# **BEFOR THE SELWYN DISTRICT COUNCIL**

# RC225180

# EVIDENCE OF PAUL ANDREW SMITH Date 16 February 2023

**Photo 1**: An example of a ribbonwood tree standing just over 2m tall and its relatively transparent appearance.

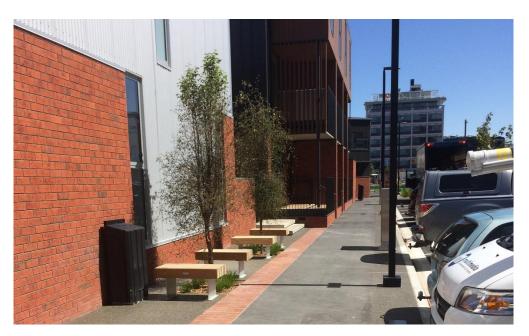
In addition to the above, Paragraph 10.3(b) of Ms Anthony's Statement of Evidence outlines that 2m tall Ribbonwood, Kanuka and Hoheria to be faster growing, bushy species to assist with immediate visual mitigation of the proposal. Ribbonwood and Hoheria are both narrow leaved, with all three plant species being relatively spindly and transparent in there juvenile years, including at 2m tall, refer to **Photo 1**.
